# PJM Manual 13:

Emergency Operations

Revision: ~~8485~~

Effective Date: ~~November 17, 2021~~ October 1, 2022

*Exhibit 1: Emergency Levels*

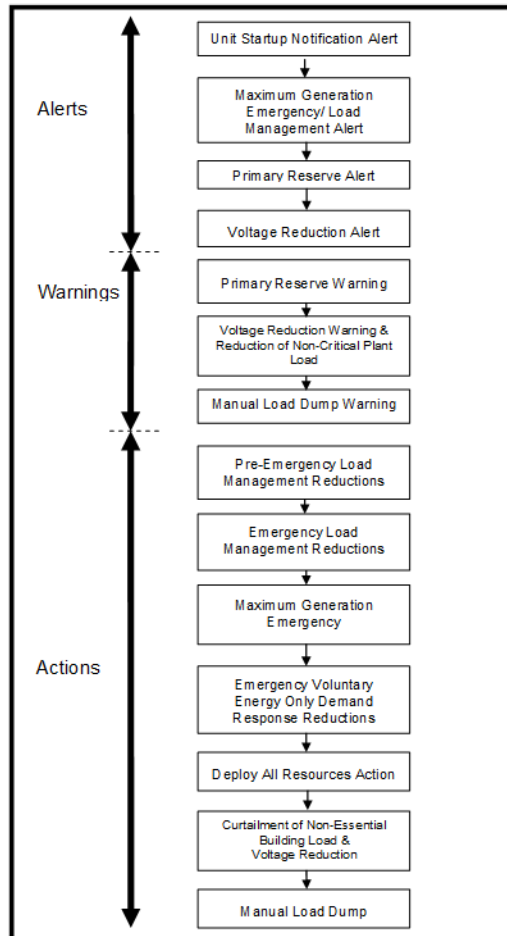
- o Correctly referenced non-critical, not non-essential, station light and power.
    - o Added a new Step 7: Deploy All Resources Action and renumbered subsequent “Steps” as well as updated Exhibit 1 accordingly.
